**SUBJECT: Transmittal of Westinghouse Responses to Open Items Identified in the AP1000  
Draft Safety Evaluation Report**

**Westinghouse Non-Proprietary Responses to  
AP1000 Draft Safety Evaluation Report (DSER) Open Items**

# AP1000 DESIGN CERTIFICATION REVIEW

Figure 15A-1

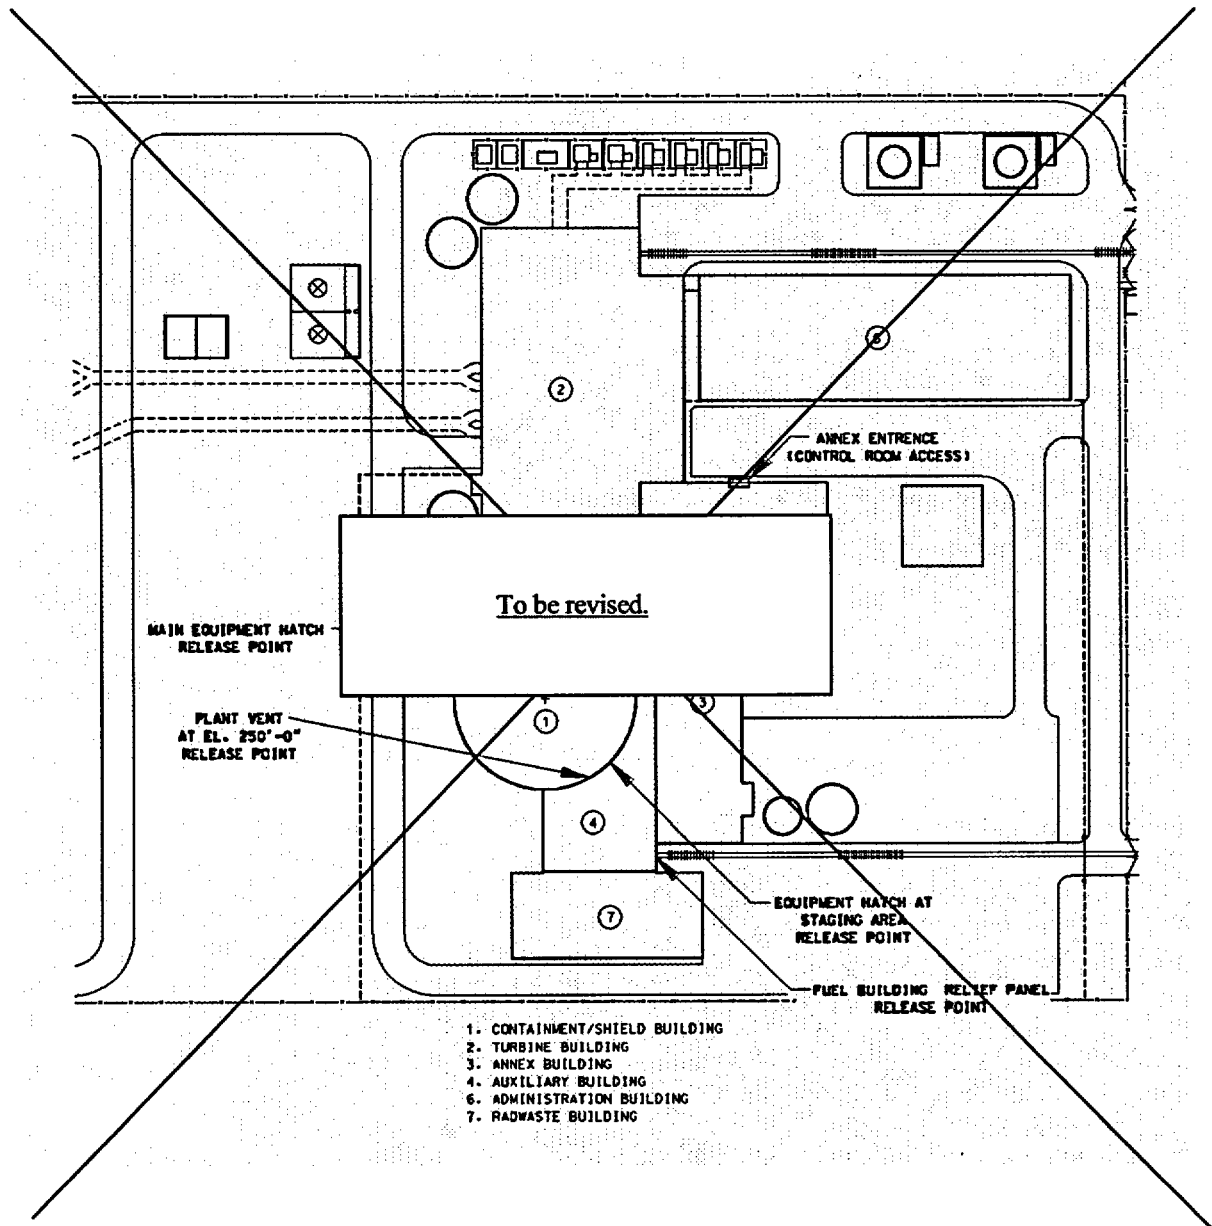
The locations of the potential release points for a Loss-of-Coolant Accident and their relationship to the main control room air intake and the personnel access door are shown in Figure 15A-1. Figure 15A-2 shows the locations of the potential release points associated with other postulated accidents relative to the possible paths for air entry into the main control room.

Figure 59-2

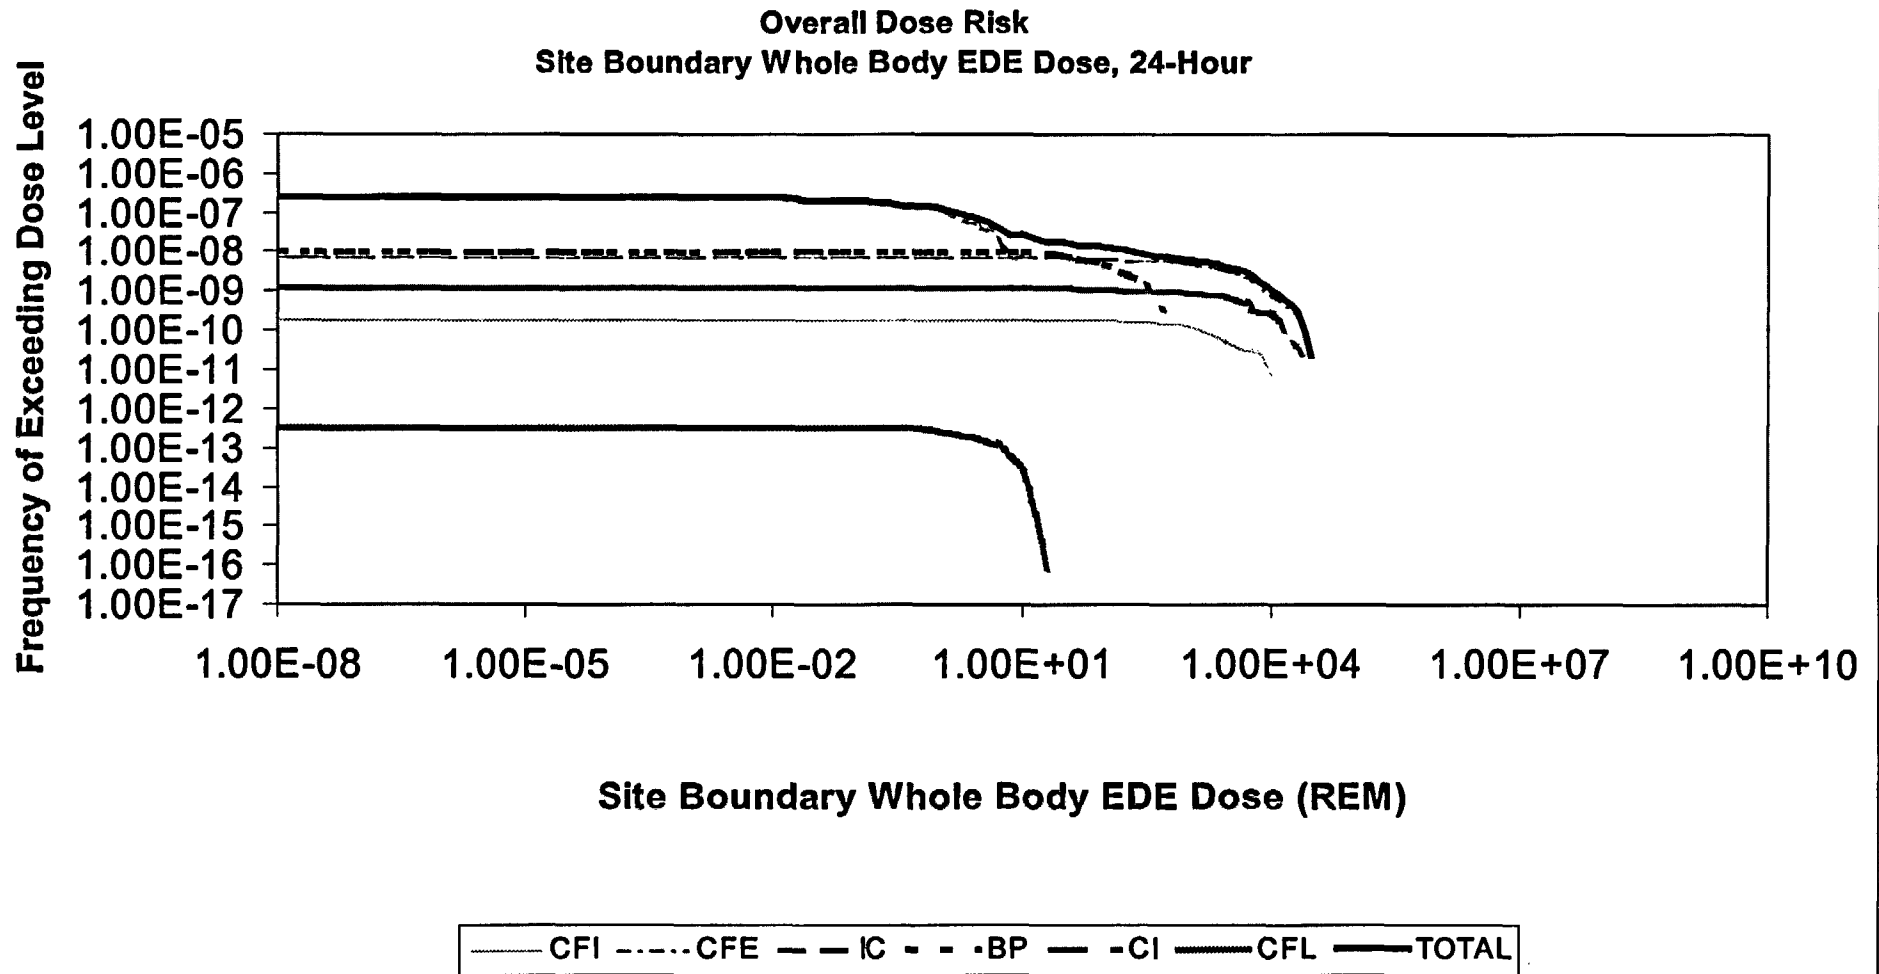
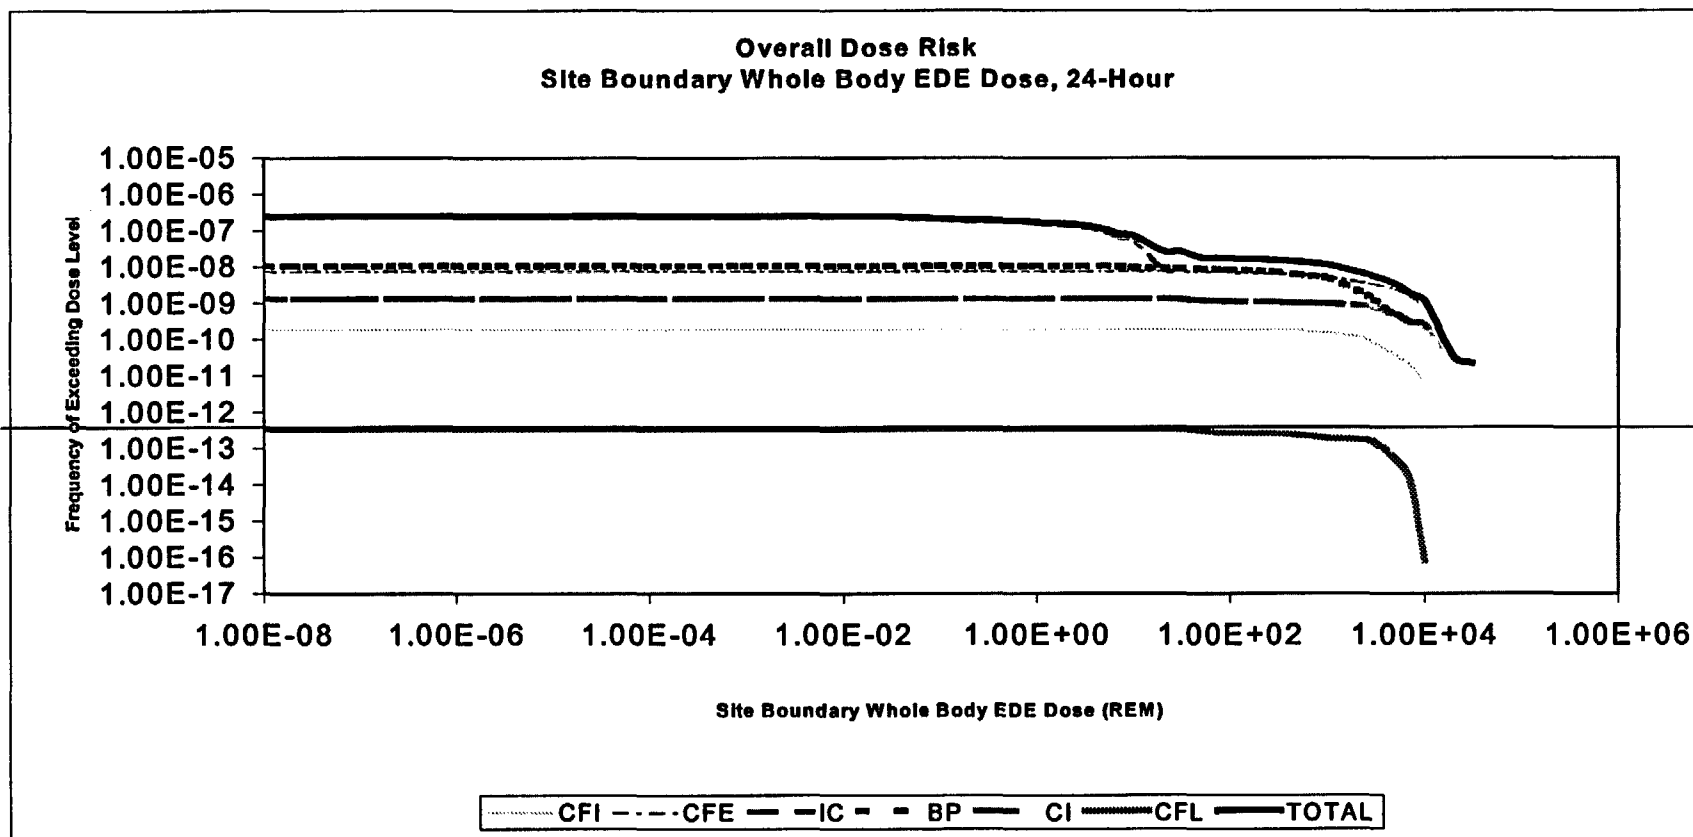
The total at-power risk from a postulated release of fission products (the 24-hour, site boundary effective dose equivalent (EDE) is  ~~$5.15\text{E-}05$~~  $1.83\text{E-}04$  rem per reactor-year. For shutdown, this risk was calculated to be  $7.1\text{E-}05$  rem per reactor-year for AP600. For AP1000, this shutdown risk could be estimated as  $9.7\text{E-}05$  rem per reactor-year (estimated the same way as shutdown LRF in Table 59-15). Table 59-16 and Figure 59-2 summarize the plant dose results.
